**Joint Regional Planning Panel
(Sydney East Region)**

JRPP No.	2011SYE112
DA No.:	DA/812/2011 – Stage 2 DA for Lot 11 to construct three(3), five (5) storey residential flat buildings containing 179 apartments, basement parking for 226 vehicles and associated landscaping works at 1408 Anzac Parade, Little Bay.
Applicant:	CHOF 5 Little Bay Pty Ltd
Report By:	Development Assessment Officer– Randwick City Council

Figure 7: Extract of central building plan for levels 1-3. The non-compliant separation between east- west facing balconies is highlighted.

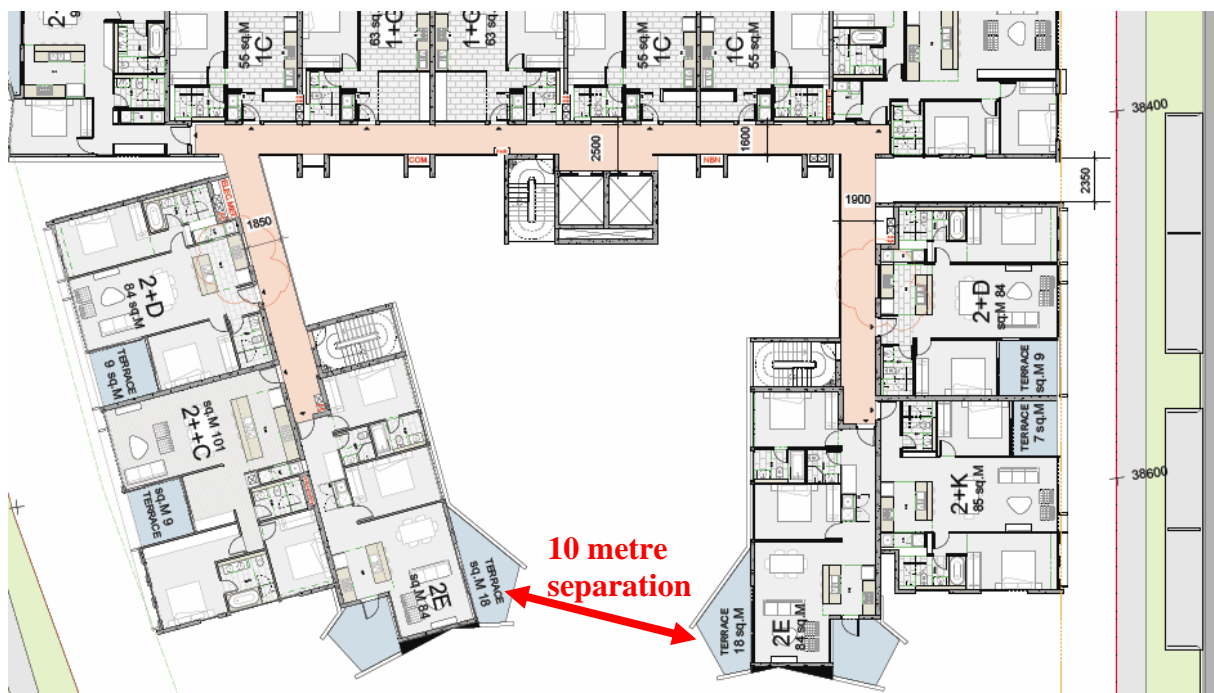
Compliance with these distances is generally achieved throughout the development, except in one (1) aspect of the central building (Building 2), where ten (10) metres is achieved between east and west facing balconies at ground floor level, up to level 3, shown in Figure 7, below.

The non-complying balconies have been designed such that view lines are directed beyond each other, through the use of blade walls. Each unit affected also features an alternate terrace, of which meets the specified privacy separation distance. Given ten (10) metres is provided between balconies, the non compliance is considered minor given the contribution each balcony makes to the overall design of the development.

As provided for under the Stage 1 Plan, there are generous separation distances within the proposed development, allowing occupants privacy from the public domain, neighbouring development and from within the proposed development. The measures outlined are considered to sufficiently mitigate any privacy impacts to occupants and neighbours.
